Oakdale West Estate Modification 9

Changes to Buildings 2A, 2C, and 2D in the approved Oakdale West Estate

State Significant Development Modification Assessment (SSD-7348-MOD-9)

December 2021

Figure 6 | Building 2C – 13.7 m high at southern elevation increasing to 22.2 m high at northern elevation

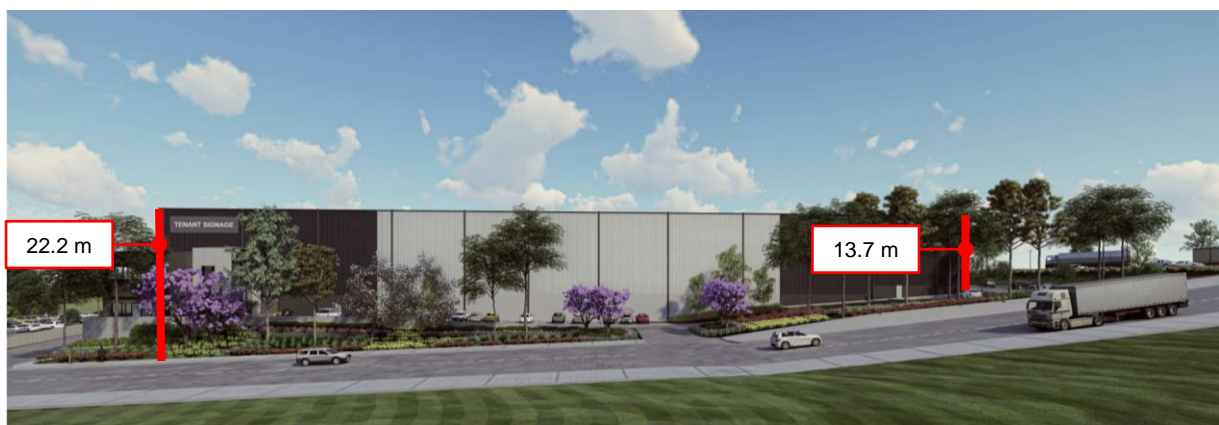
The Applicant proposes to modify the OWE Concept Plan to increase the height of Building 2C from the approved 13.7 m to 22.2 m. The effective building height is still only 13.7 m as the building sits on sloping land that drops around 10 m from the south to the north, see **Figure 6** and **Figure 7**. A retaining wall would be constructed along the west, east and northern sides and would be integrated into the building structure, making the height appear as 22.2 m when measured from the lowest point on the site. Importantly, there is no change to the finished roof level compared with previously approved modifications. The Applicant noted this design would provide a better visual outcome than filling up to the approved pad level, which would then require retaining walls along the road frontage.

The Department has reviewed the VIA and consulted Council on the proposed modifications to building layouts and heights. Council did not raise any concerns with the height of Building 2A but noted the 22.2 m height of Building 2C would result in a poor streetscape outcome.

The 22.2 m height of Building 2C has already been considered as part of MOD 6 (as the roof height is unchanged). This assessment concluded the building would be largely screened from view by buildings that would be constructed between Building 2C and the residences and school to the west. The 40 m wide landscaped bund would minimise visual impacts on Emmaus Catholic College once the landscaping matures. The Applicant's proposed landscaping includes a minimum 7 m wide landscaped verge along the western boundary, which would soften the views of the building over time, see **Figure 10**.

Figure 10 | Building 2C and 2D – Landscape Plan

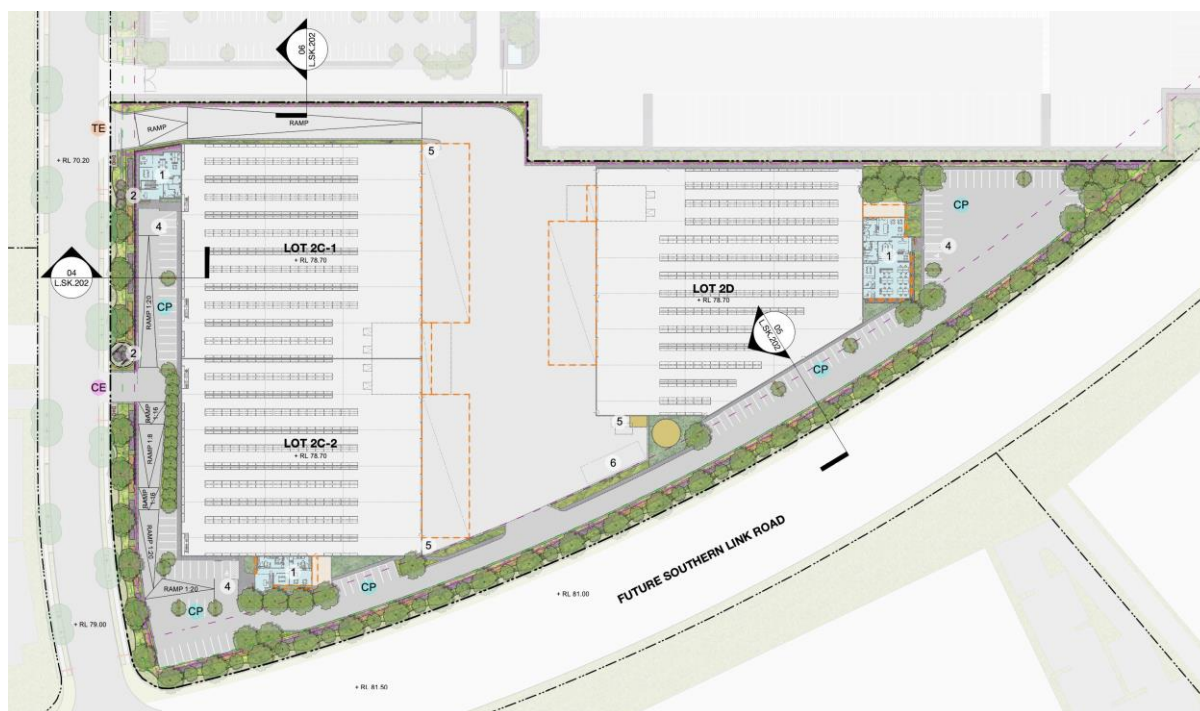
Visual impacts on the single residence to the south would remain high as originally assessed in the OWE Concept Plan and previous modifications. The landowner has indicated a preference for no landscape screening as it would interrupt the long-range views of the Blue Mountains. The Department notes there is limited opportunity to reduce the visual impacts from this location, but notes the office for Building 2C is located on the southern elevation, which would provide some architectural features to break up the façade of the building when viewed from the residence to the south, see **Figure 9**. A minimum 7 m width of landscaping along the southern boundary would assist in reducing the visual impacts of the building once the landscaping matures, see **Figure 10**.

from the future Southern Link Road intersection, or demonstrate the proposed location would not cause queuing or delays at the intersection. Council supported the resolution of the safety issues but noted it did not support the corresponding reduction in landscaping along the SLR frontage.

The Applicant's RTS provided updated landscaping plans, including additional planting along the driveway and inclusion of a landscaped roundabout within the carpark of Building 2D to address Council's concerns. The Applicant considered relocating the carpark access further north, but indicated this would require 2.5 m of cutting and lowering the office ground floor level, creating a greater height difference between the office and warehouse building. The Applicant confirmed the TA had considered the queue length between the future SLR and the carpark access and noted there is adequate capacity for queuing during peak hour traffic in the 2036 scenario. The car park access is approximately 100 m from the SLR intersection and the maximum queuing length is estimated to be 61 m.
